PRODUCT SERVICE NOTICE

2200 SVP OPTION W BOARD INSTALLATION

This PSN provides installation, checkout, and operating instructions for the optional 210-7486 Multi-Terminal SVP Board (Option W) used to replace the original 2200 SVP Board (P/N 210-7789). The Multi-Terminal SVP Board supports one, two, or three workstations and a printer. The original 7789 board supports only one workstation and a printer.

ECO NO 49287
 SHEET 2 OF 1

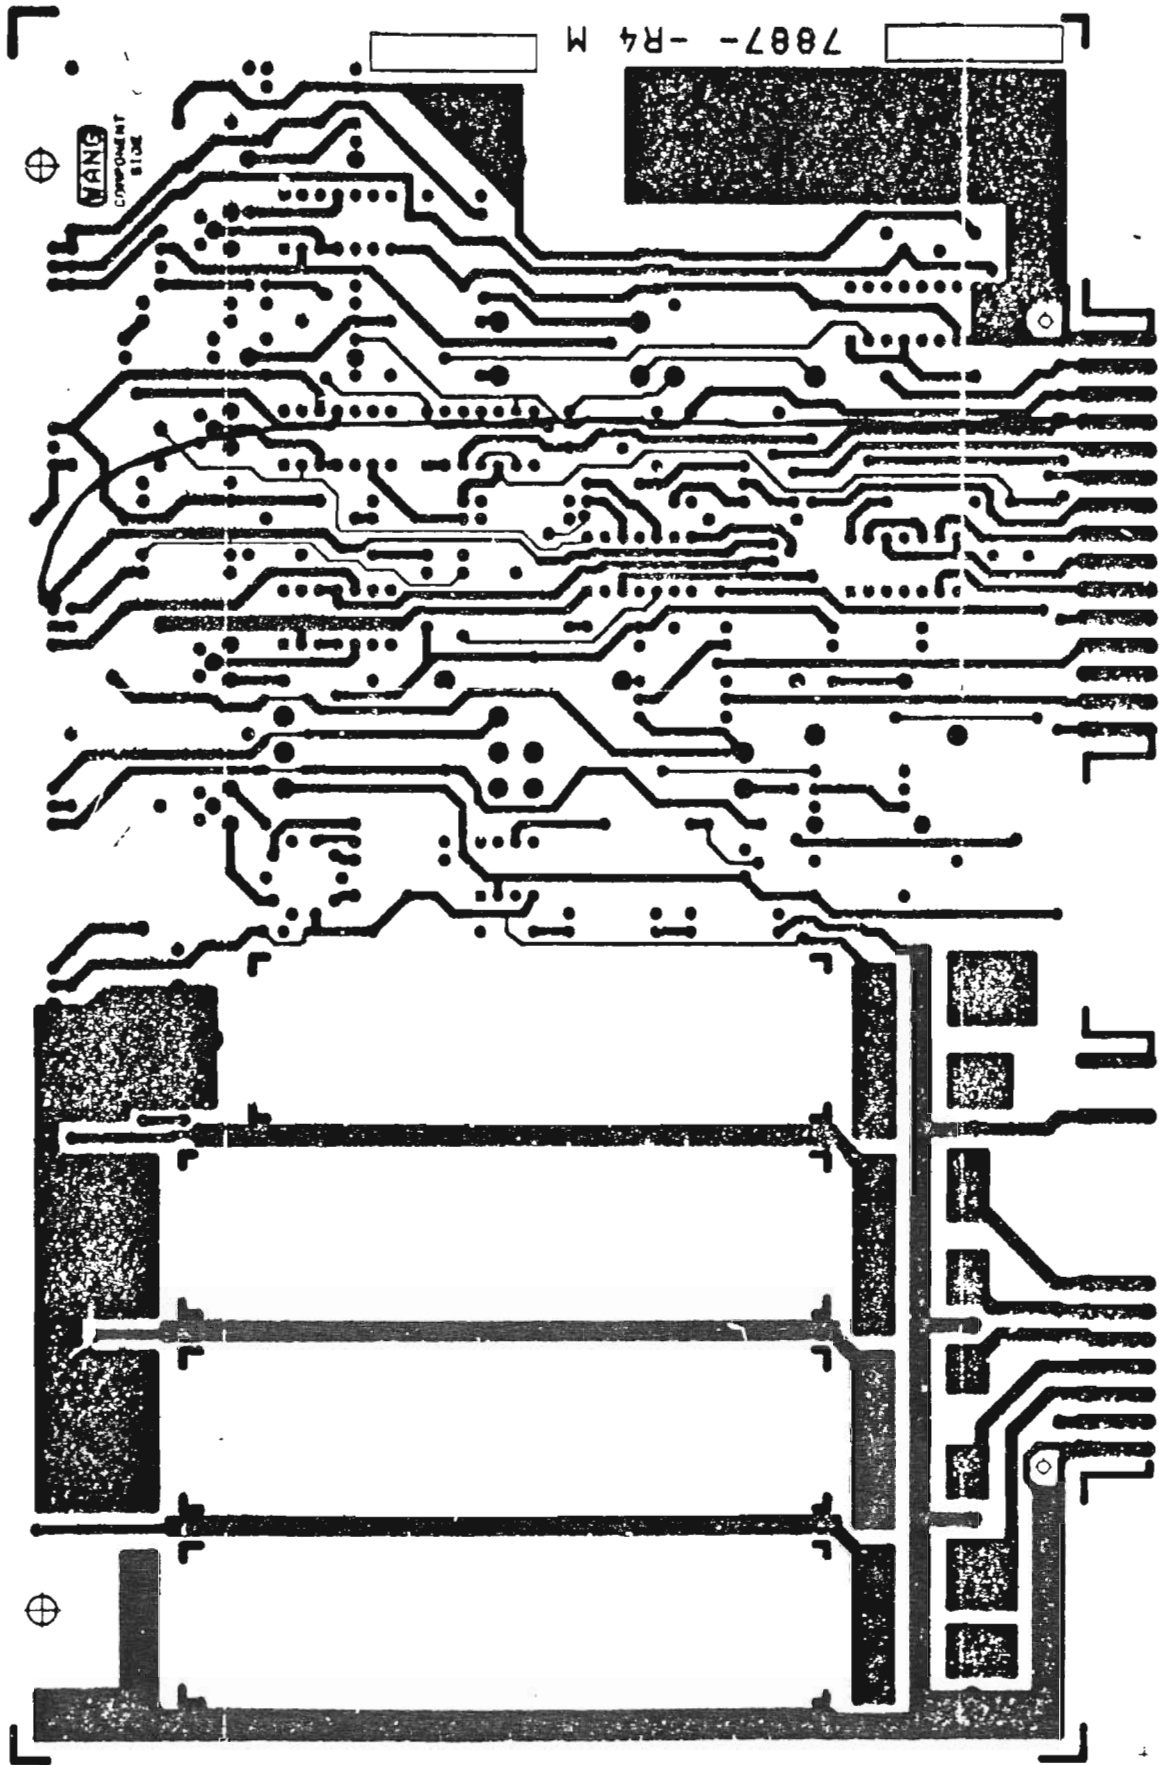
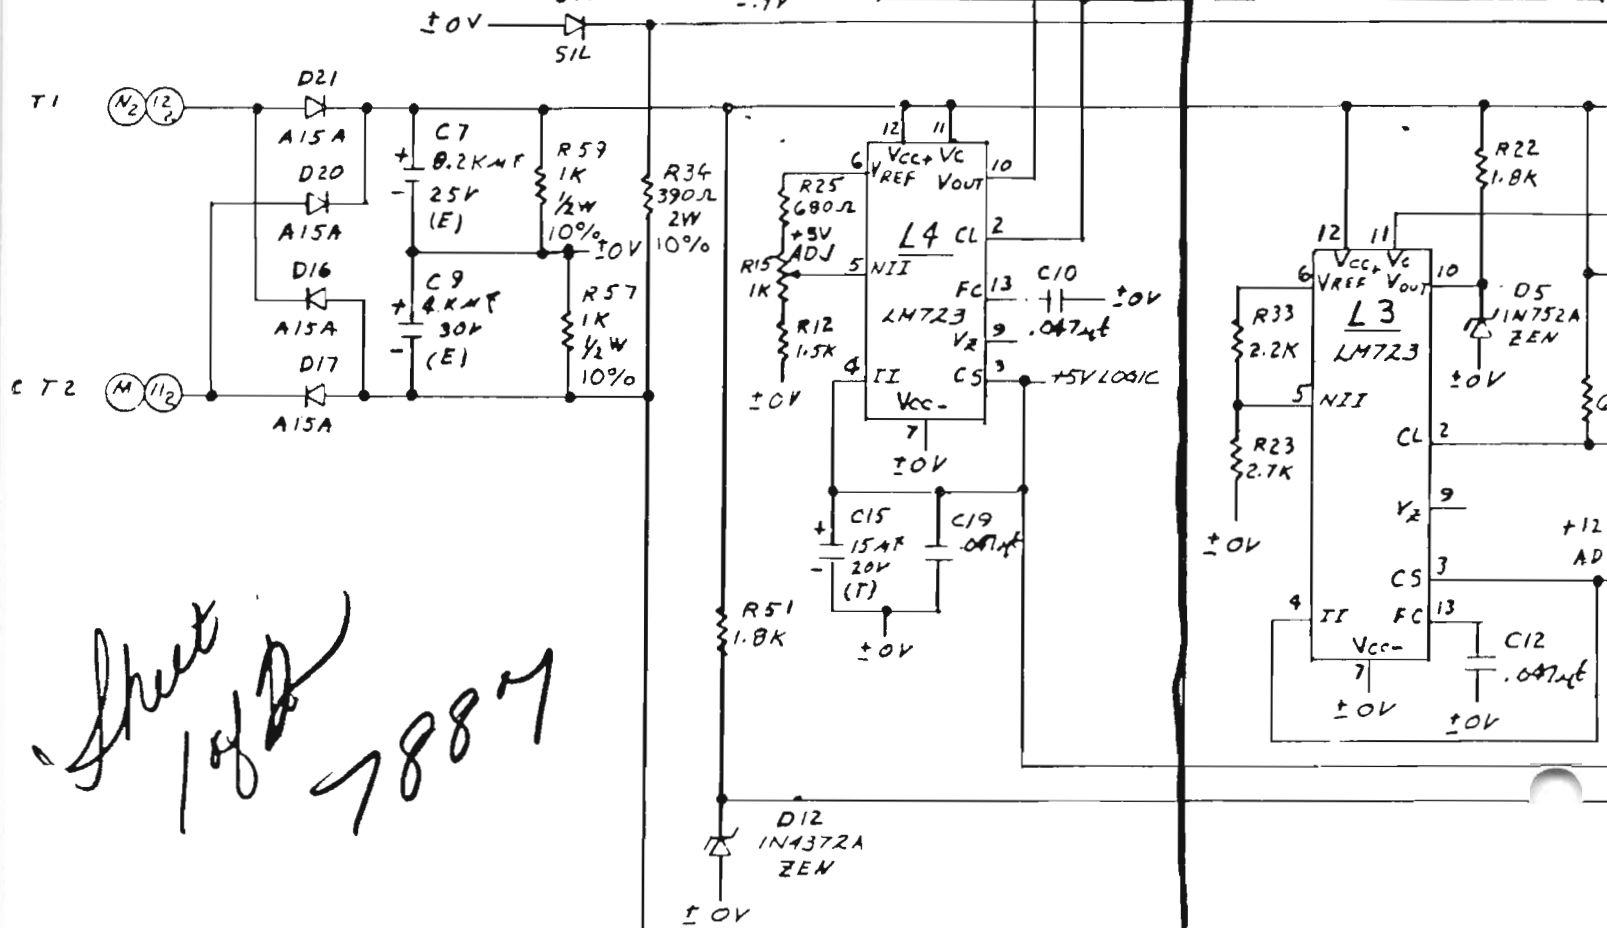
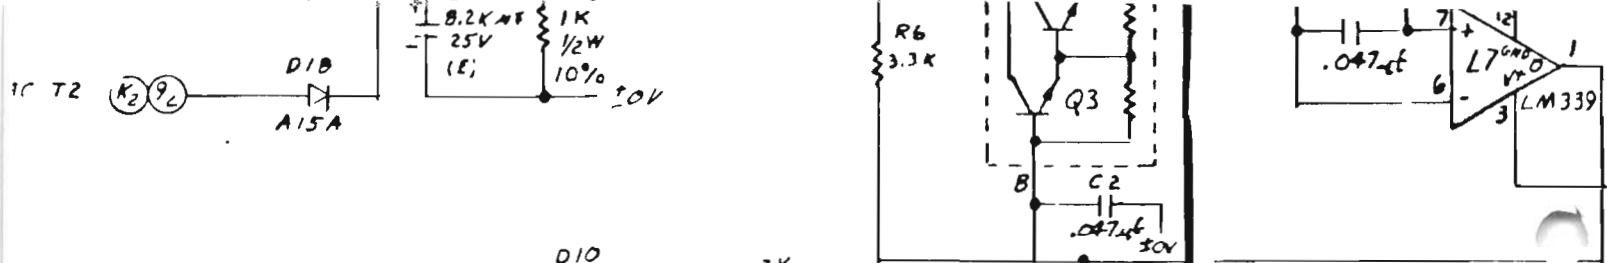
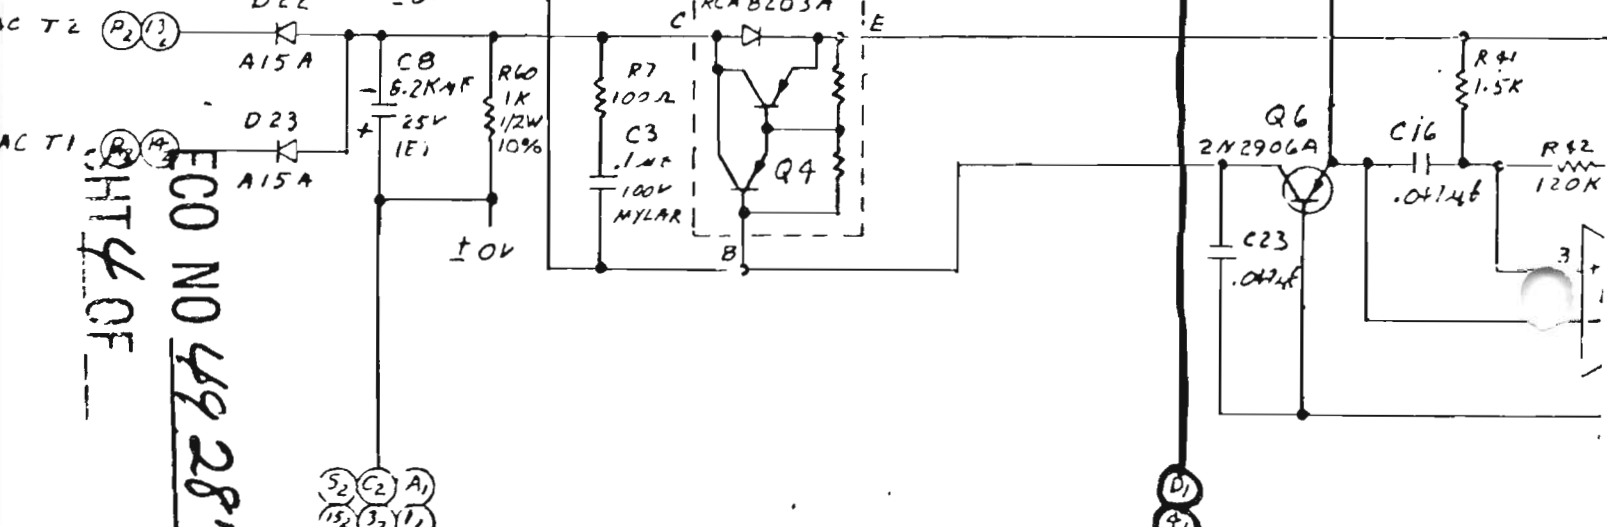
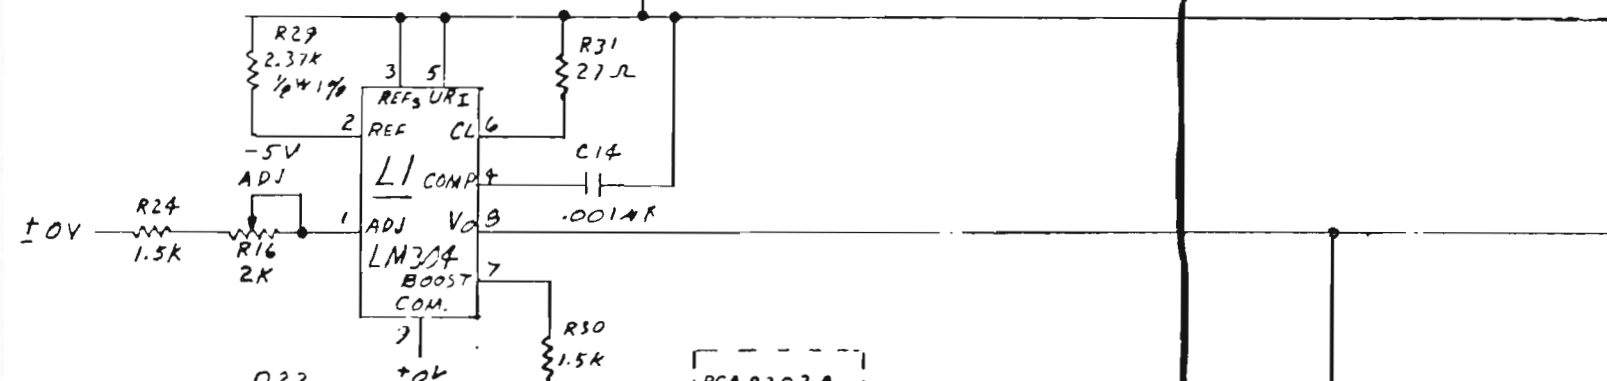
Change assembly drawing, schematic, parts list and sample board per attached prints and as follows:
 Rework Instructions:
 Add teflon jumper wire from Q3 emitter to plate thru hole at (4 D 1).
 Remove nylon screw at Q3. Replace with insulated shoulder washer and #4 screw and nut.
 Change BOM 210-7887 as follows:

REASON/SYMPATOM FOR CHANGE
 JUN 22 1988
 Teflon jumper wire to prevent etch at Q3 emitter from burning.
 Nylon hardware at Q3 melts causing +5 volt failure.

ADD 24 GA JUMPER
FROM Q3 EMITTER TO
PLATE THRU HOLE AT 'D1 4
